Walashek Enterprises Inc.

Please find the enclosed revisions to our application as requested by your letter of 9 MAY 85.

RADIOGRAPHER'S TEST

QUESTION NO. 15

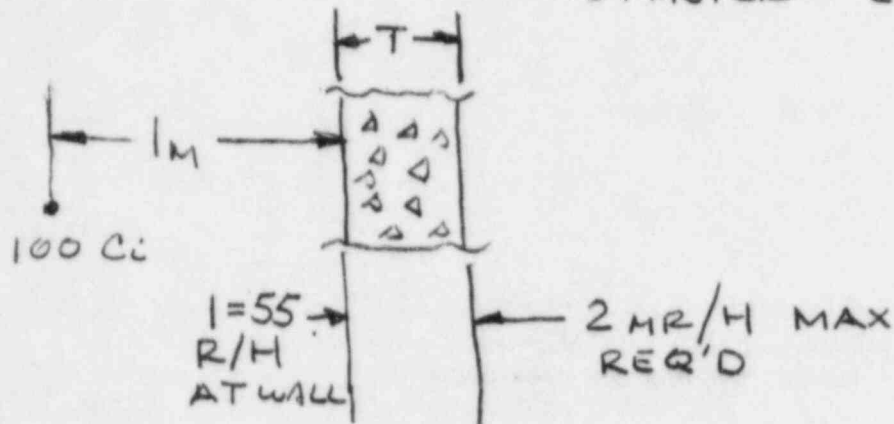
Regarding questions 5 and 15 of the radiographers test, I have recalculated the problems and arrive at the same answers and have attached my solutions.

$RHM/C = .55R$ MCMASTER 13.16 FIG 8

HALF-VALUE LAYER CONCRETE = 1.9 IN

MCMASTER 26.9 FIG 6

2	55,000
2	27,500
2	13,750
2	6,875
2	3,437.5
2	1,718.88
2	859.44
2	429.72
2	214.86
2	107.43
2	53.72
2	26.86
2	13.43
2	6.72
2	3.36
	1.68 MR/H

$$15 \text{ HVL} \times 1.9 = 28.5$$

APPROX 28 IN
